SITE PLAN FOR
 JOHN OKOBOH

PETITION NO: Z-81
HEARING DATE (PC): 09-08-16
HEARING DATE (BOC): 09-20-16
PRESENT ZONING: R-20
PROPOSED ZONING: FST

Z-81-2016 GIS

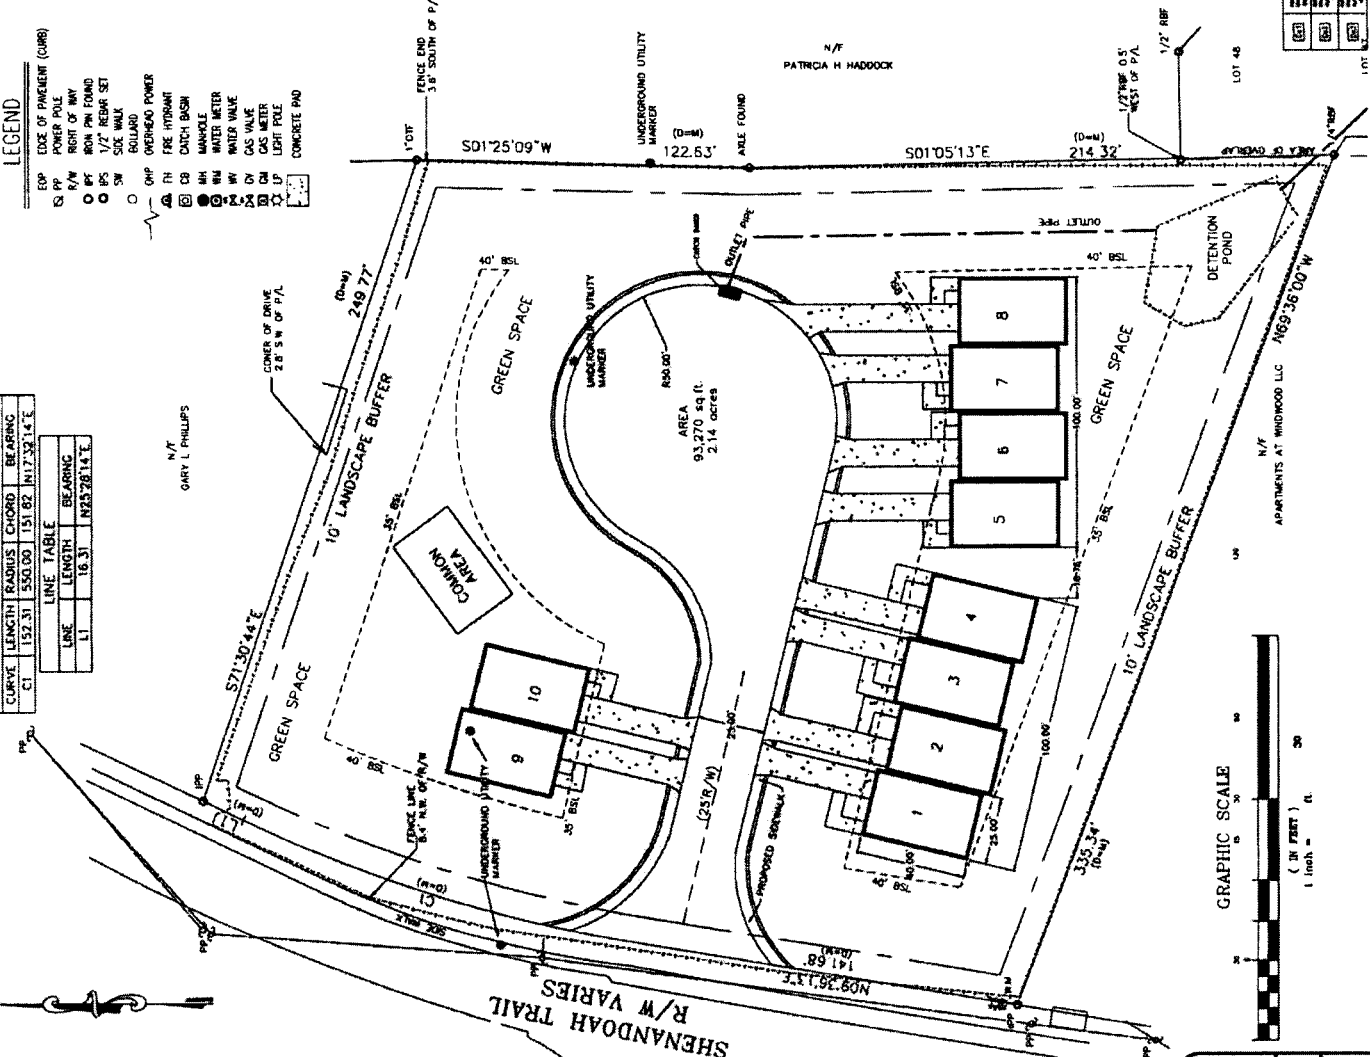
- Provide comprehensive hydrology/stormwater controls to include development of out parcels.
- Submit all proposed site improvements to Plan Review.
- Any **spring activity** uncovered must be addressed by a qualified geotechnical engineer (PE).
- Structural fill _____ must be placed under the direction of a qualified registered Georgia geotechnical engineer (PE).
- Existing facility.
- Project must comply with the Water Quality requirements of the CWA-NPDES-NPS Permit and County Water Quality Ordinance.
- Water Quality/Quantity contributions of the existing lake/pond on site must be continued as baseline conditions into proposed project.
- Calculate and provide % impervious of project site.
- Revisit design; reduce pavement area to reduce runoff and pollution.

- No Stormwater controls shown _____
- Copy of survey is not current – Additional comments may be forthcoming when current site conditions are exposed.
- No site improvements showing on exhibit.

1. This parcel is located on the east side of Shenandoah Trail at the intersection of Landmark Way. The existing site is mostly wooded with average slopes ranging from 10 to 25%. The site drains to the south and east into and through the adjacent Apartments at Wildwood and Hillcrest Estates Subdivision.
2. The site is proposed to be served by a single stormwater management pond at the low point of the site near the southeast corner. A drainage easement will be required from the one of the adjacent property owners to accommodate the proposed concentrated discharge.
3. This will be a private development, therefore the stormwater infrastructure will be maintained by the HOA.

Recommend development street directly align with Landmark Way per Development Standard 401.10.

Recommend curb, gutter, and sidewalk along the Shenandoah Trail frontage.

Recommend curb and gutter along both sides and sidewalk along one side of proposed development roadway.

1. Site plan received by the Zoning Division on August 5, 2016 with District Commissioner approving minor modifications;
2. District Commissioner to approve building elevations;
3. Water and Sewer Division comments and recommendations;
4. Stormwater Management Division comments and recommendations;
5. Fire Department comments and recommendations; and
6. Department of Transportation comments and recommendations.
